Highways Technical Note

Project: : 8-10 Moor Lane, South Shields, NE34 6BZ
Ref: ST/0140/24/FUL
Date: 18th July 2025

1.1.1 This technical note provides updating information to the highway authority South Tyneside Council (STC) for the above application dated 11th December 2024.

TRACKING PLAN

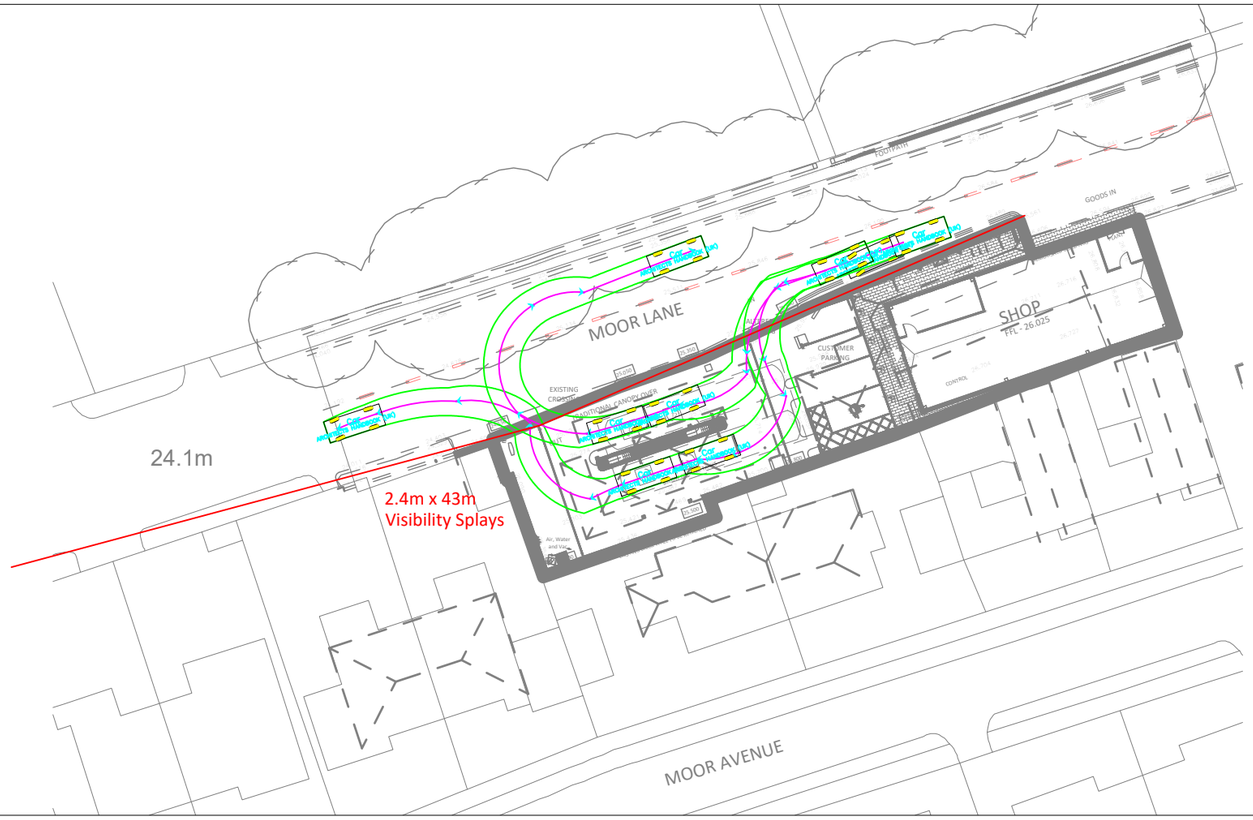
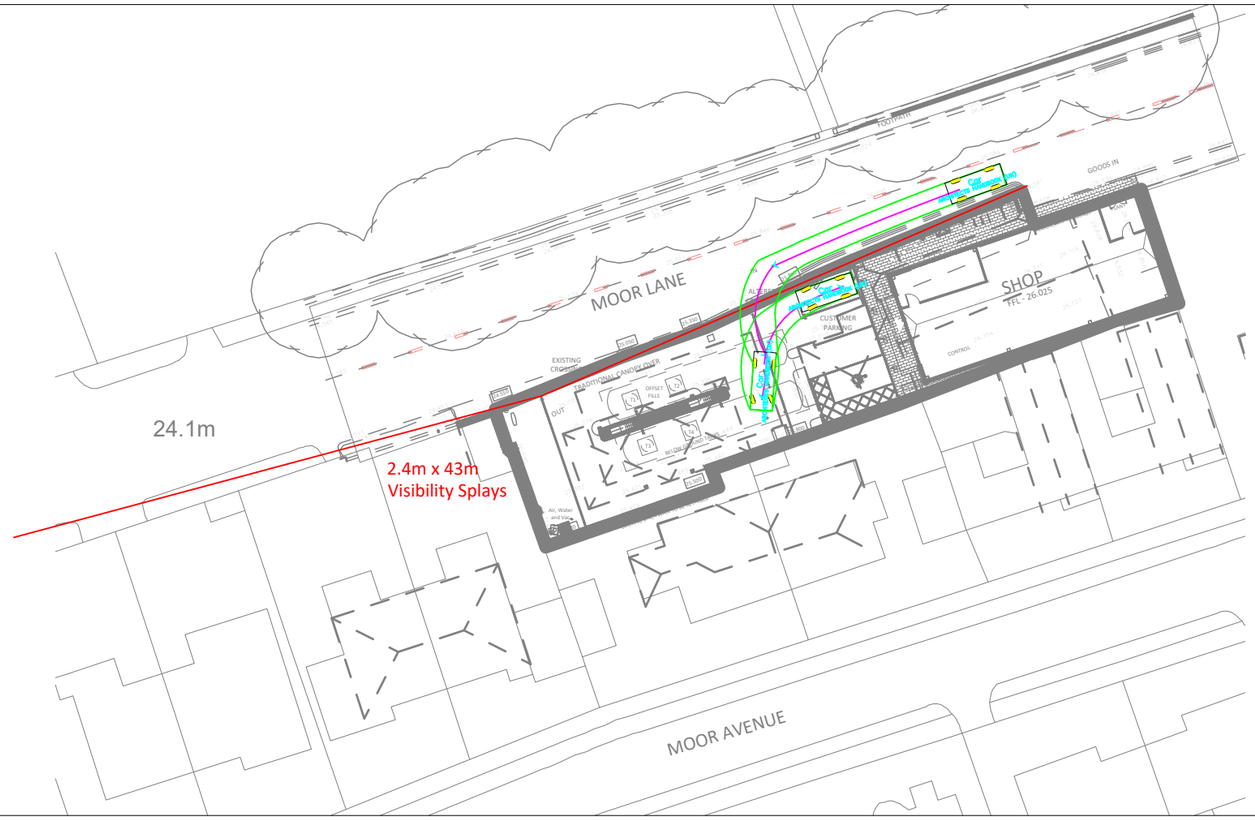
Notwithstanding the issues of highway land encroachment mentioned above, the proposed service area for goods is located to the north-east corner of the development site, accessed directly from the highway carriageway edge with no inter-visibility. In addition, no swept path of vehicles or details of service vehicles have been provided to show how the servicing arrangements could be satisfactorily and safely accommodated, including avoiding any reversing manoeuvres of service vehicles on the highway carriageway into the path of vehicles travelling along Moor Lane, particularly in close proximity of the Sunderland Road junction 28m further east.

The swept path/tracking of a service vehicle/tanker accessing and egressing the garage forecourt site is shown in the opposite direction of the general one-way vehicular flow proposed for the garage. Please provide tracking for the correct direction of vehicle flow, unless the current one-way system is to be retained due to concerns raised in point '3' above.

1.1.3 The development would be serviced by oil tankers and 10-12m HGVs. Tracking is shown in **Appendix B** for the worstcase assuming a 16.5m artic.

1.1.7 The one-way system has been amended to ingress from the east and egress from the west.
